12-734, 15-730, 15-734, 15-736 & 15-738

Ford 5.0 Coyote Oil Pans.

OE Tray Installation

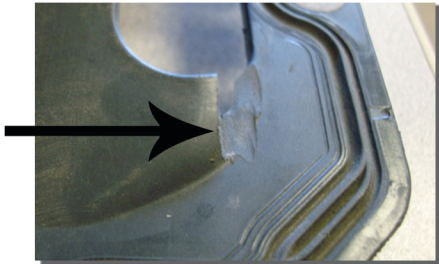
When installing these oil pans the oil pan locating pins on the factory Coyote windage tray will need to be removed. These pins aid in production assembly of the engine, but are not required for this installation. To make the modification cut off the plastic pins and file the spot smooth so the oil pan and the tray lay flat against each other.

The OE windage tray/gasket combination (BR3Z 6710-A) can be used with slight modification. The windage tray will need to be trimmed on the back side of the motor on both sides as shown in the image below.

15-738 Front Sump Pan.

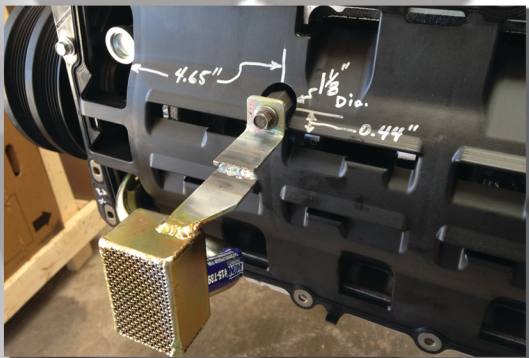
Due to the lack of OEM front sump Coyote applications there are a few modifications needed to properly install our front sump coyote pan.

Image left shows the location you will need to modify the tray in order to properly mount the pickup tube. In addition to this modification you will also need to move the pickup mounting bolt from the OE position to this location.
